Subject: Transnuclear, Inc. (TN) Input for the Response to the United States Nuclear Regulatory Commission (USNRC) Request for Additional Information for Revalidation of Model No. MFC-1 (Japanese Competent Authority Certificate J/105/AF-96, Rev. 2) (Docket No. 71-3043; TAC No. L24445)

General Description Review

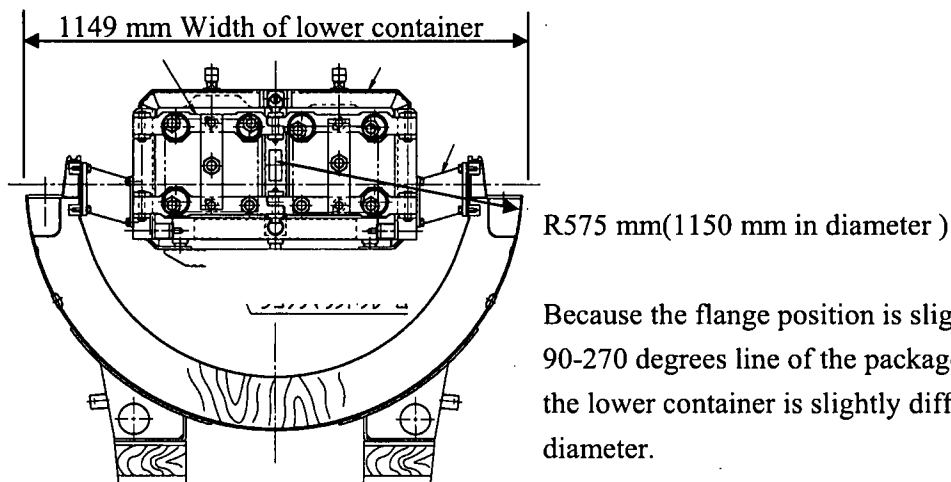
G2 - Clarify the diameter of the lower container.

The lower container diameter shown on Figure I-C.6 provided by the applicant does not agree with the diameter stated in paragraph C.2.1 (2).

The diameter of 1150 mm is correct but the dimension of 1149 mm shown in Figure I-C-6 is not diameter but rather is the maximum width of the lower container. Please refer the following figure.

Because the flange position is slightly lower than 90-270 degrees line of the package, the width of the lower container is slightly different from its diameter.

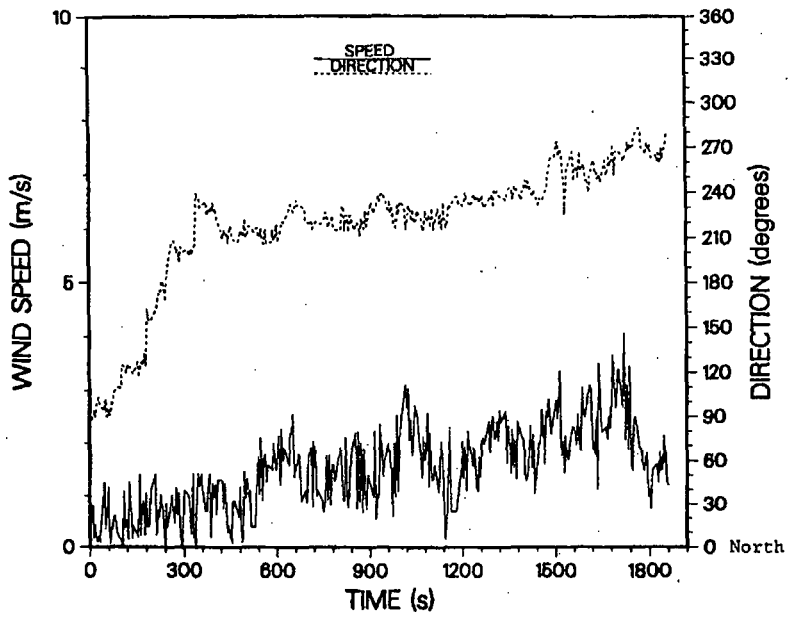
T1 - Perform HAC thermal analysis using appropriate coefficients or prove that the analytical approach employed in the application submittal is at least as conservative as that required by the regulations.

The applicant performed a HAC thermal analysis of the package exposed to a fire, and indicated in the SAR that a value of 0.9 was used as the flame emissivity and 0.8 was used as the surface absorptivity coefficient. During a conference call, the applicant stated that a configuration factor was calculated using the values of 0.9 for the flame emissivity and 0.8 for the surface absorptivity coefficient. The configuration factor calculated, and subsequently used in the TRUMP code to determine the maximum package temperatures, was 0.735. This value of 0.735 is considered by the staff to be non-conservative irregardless if it is used as either an emissivity or an absorptivity coefficient. In addition, the SAR does not show that using this configuration factor provides analytical results which are at least as conservative as those which would be obtained if either a flame emissivity coefficient of 0.9 or a surface absorptivity coefficient of 0.8 were employed.

Also, the applicant specified in the SAR that natural convection heat transfer from the surface of the package was employed instead of forced convection during the 30-minute HAC fire. The applicant also specified that natural convection and radiation heat transfer were used in the HAC analysis during the cooldown period. Although the staff finds the use of natural convection and radiation heat transfer appropriate during the cooldown period, the staff considers using a natural convection heat transfer coefficient during the HAC 30-minute fire a non-conservative boundary condition because the differences in the convective coefficient between natural convection and forced convection are not negligible.

In accordance with what the NRC pointed out, the applicant has carried out the re-calculation of the maximum temperature of the fuel cladding of accommodated fuel assemblies and external/inner surface of the outer container under the following conditions

- 1) *Treatment of emissivity in the atmosphere of 800 degrees C for 30 minutes*
SAR: *atmospheric emissivity = 0.9 packaging surface = 0.8 (0.735 as configuration factor)*
Re-calculation: *flame emissivity of 0.9 and 100% radiation absorption from the flame*

- 2) *Convection between the atmosphere and surface of the package in the atmosphere of 800 degrees C for 30 minutes*
SAR: *natural convection ---Nu = 0.53*(Gr*Pr)^(1/4)*
Re-calculation: *forced convection----Nu = 0.036*Pr^(1/3)*Re^0.8 (Colburn's formula) [1]*

According to Figure 1, gas velocity during a pool fire is generally assumed to be 5 m/s or less. Heat transfer coefficients were calculated considering it as 10 m/s on the conservative side. The calculation results are shown in Table 1.

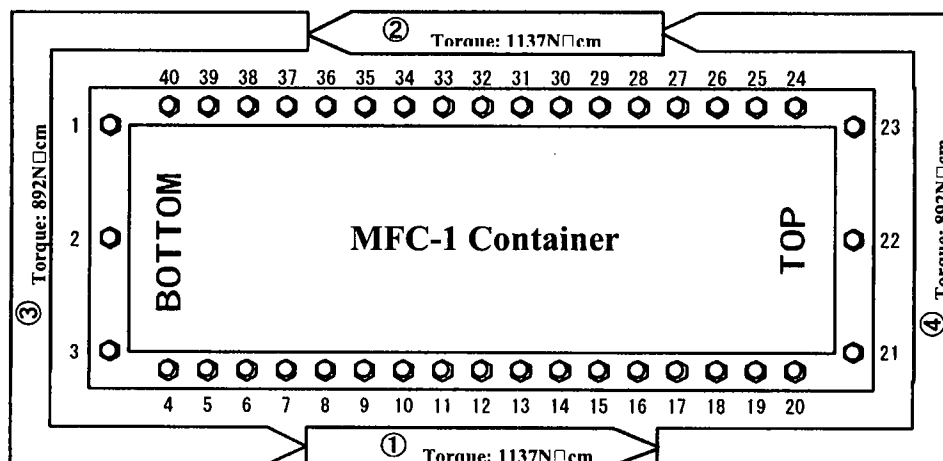
P3 - Clarify the method used to secure tightening bolts (Figure IV-AS) in paragraph (8)(c) of Section A1.2 "Loading Procedures".

Neither Figures IV-AS and IV-A6 nor the instructions in paragraph (8)(c) of Section A1.2 clearly indicate what prevents the tightening bolts from being inadvertently removed during transit.

The procedure of the securing main body fastening bolts (40 sets) are shown as follows and the following information will be added in the paragraph (8)(c).

- (1) *Tighten quarter-turn bolts until specified position (90 deg. clockwise) using open ended spanner.*
- (2) *Tighten setscrew of quarter-turn bolts using hexagon socket screw torque wrench (1137N-cm and 892N-cm) in accordance with the following order, (reference the following figure).*
 - 1) *Tighten the first nine (No.8 to 16) bolts with torque of 1137N-cm*
 - 2) *Tighten the second nine (No. 28 to 36) bolts with torque of 1137N-cm*
 - 3) *Tighten the third eleven (No. 37 to 40, 1 to 7) bolts with torque of 892N-cm*
 - 4) *Tighten the third eleven (No. 17 to 27) bolts with torque of 892N-cm*
